**1 Products affected**

**3 Detailed description of change**

Product Change Notification					FEU improvement		
owner	creation date	release date	released by	change order no	rev	page	D10-003-795
dislercy	2016-05-02	2017-06-02	nowakfr	2010314	A	1 of 2

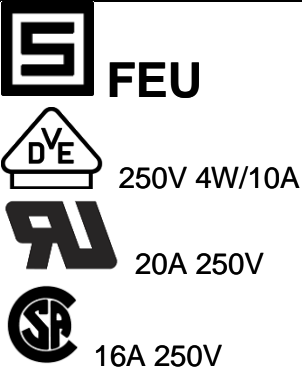
- Change of material
- Modified label
- Change of marking
- Improved voltage rating
- Improved electrical contact

The new materials fulfil the enhanced glow wire requirements according to the updated standard IEC 60127-6:2014 and are free of halogenated flame retardant and red phosphorus.

Old product approval		New product approval	
<b>UL 512</b> 20A, 250V <b>CSA C22.2 no. 39</b> 16A, 250V <b>IEC 60127-6 (VDE)</b> 4W, 10A, 250V AC		<b>UL 4248-1 - CSA C22.2 no. 4248.1</b> 20A, 600V AC or DC  <b>IEC 60127-6:2014 (VDE)</b> 4W, 10A, 250V AC	
Old label		New label
